Re: Workplan Addendum: Fuel Leak Case No. RO0000346 and GeoTracker  
Global ID T0600100920, BP #111105 / Shell 17-1455, 3519 Castro Valley  
Boulevard, Castro Valley, CA 94546

This workplan addendum was prepared to address ACEH's technical comments regarding SOMAs March 9, 2009 "Site Conceptual Model and Workplan to Address Data Gaps". ACEH recommended eliminating borings DP-4 and DP-5 due to their close proximity to monitoring well ESE-5 and the limited benefit that data from these borings may offer in increasing understanding of site conditions and addressing the current data gap. SOMA agrees with ACEH and has removed borings DP-4 and DP-5 from the workplan. The remaining borings have been renumbered and their locations are shown in the attached figure.

Site Map Showing Locations of Proposed Monitoring Well and Soil and Groundwater Borings

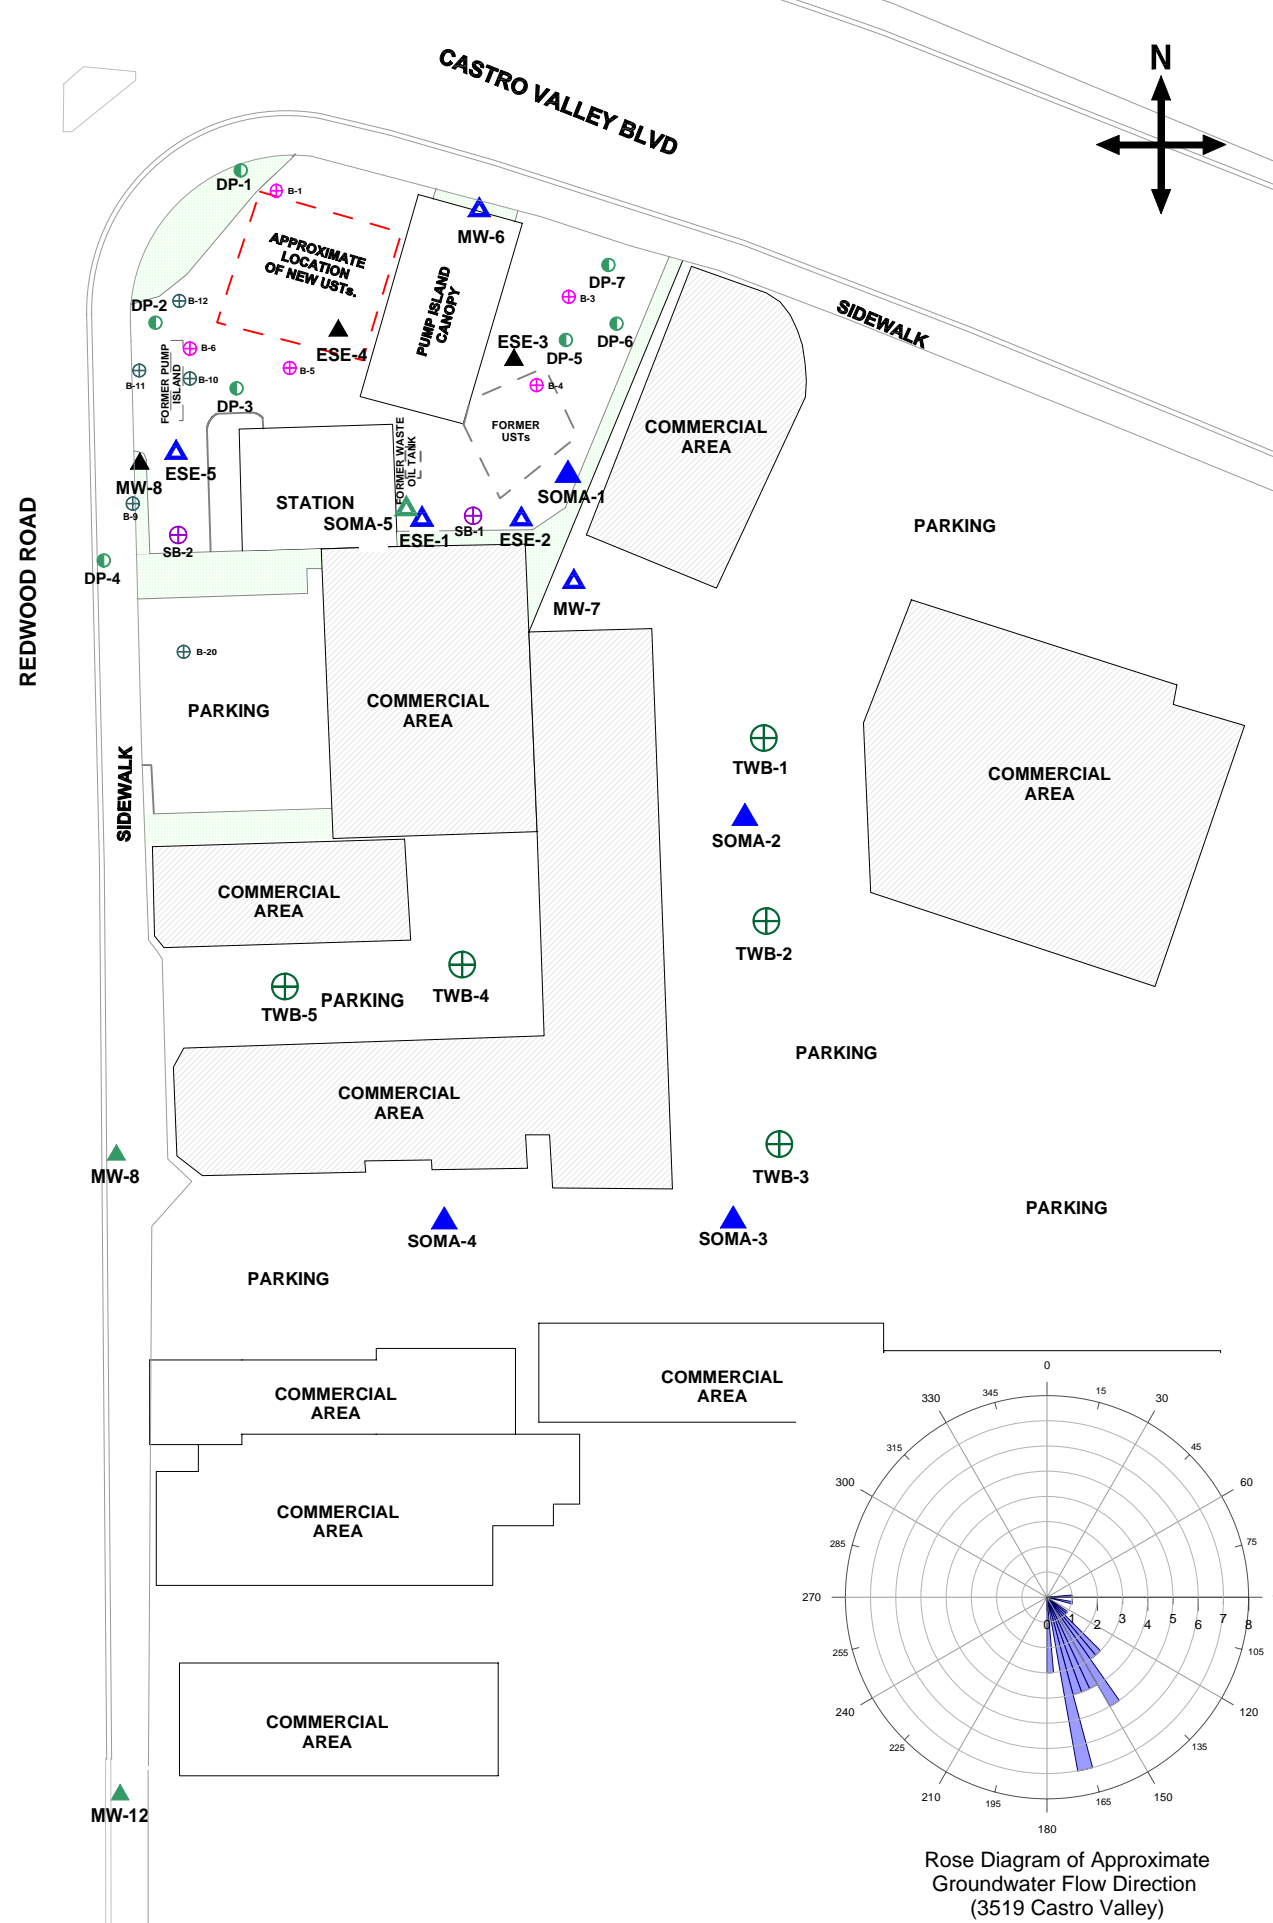
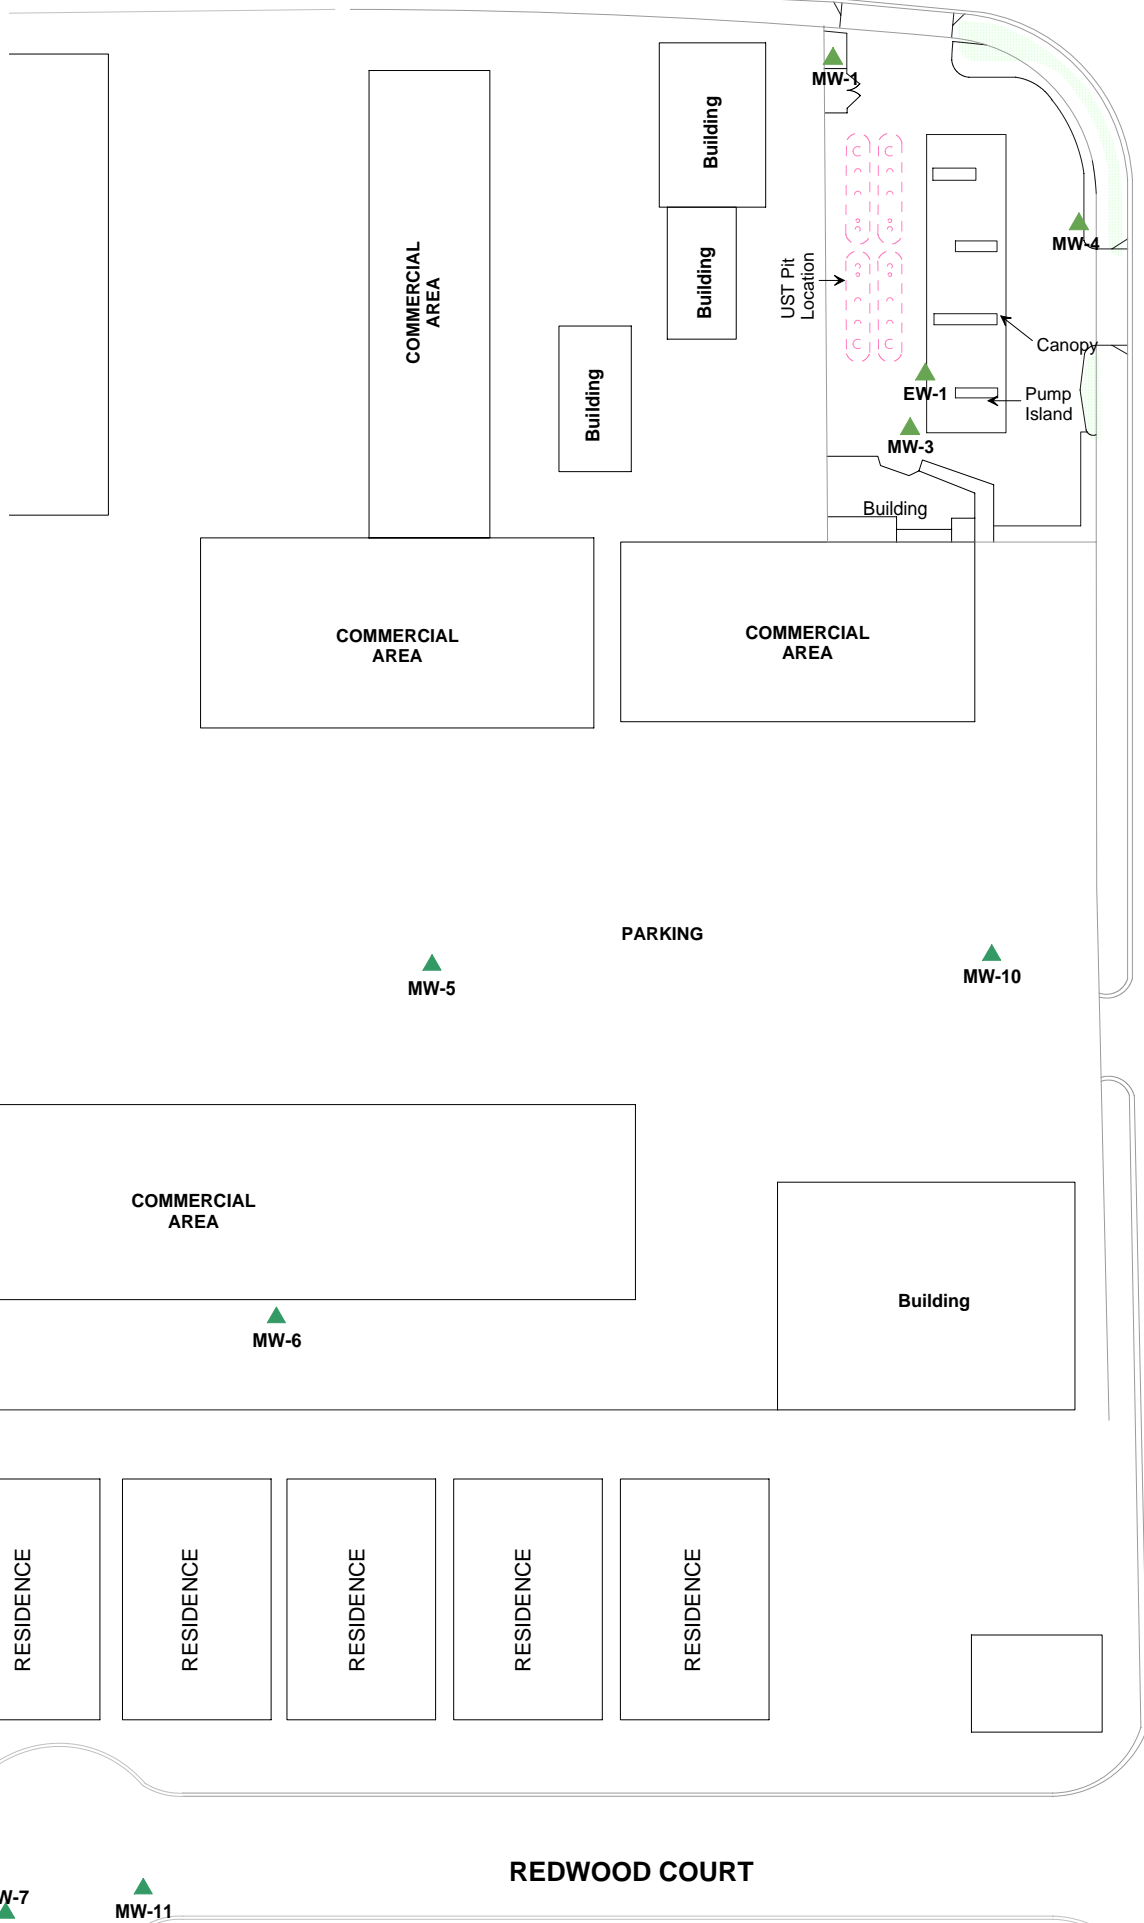
ACEH suggested that determining whether groundwater at the site is semi-confined to confined or unconfined is a current data gap and requested that SOMA address it in our proposed work. To address this data gap, SOMA proposes advancing a shallow groundwater monitoring well within the vadose zone, adjacent to ESE-1. The monitoring well (SOMA-5) will be advanced by using hollow-stem drilling techniques to 15 feet bgs (within the confining unit and above the water-bearing permeable zone) and screened from 5 to 15 feet, across the potentiometric surface. The well boring will be continuously cored and logged to characterize the hydrogeologic characteristics. The core will be screened using a PID and results documented on a geological log. Soil samples will be collected at intervals of elevated PID readings, staining or odor. SOMA-5 will be constructed of 2-inch-diameter Schedule 40 PVC casing with the screen interval constructed using 0.02-inch diameter pre-slotted PVC casing. Filter pack material will consist of No. 3 Monterey sand. Actual well depth and screen interval will be based on field observations. The well will be completed at existing grade with a traffic-rated vault.
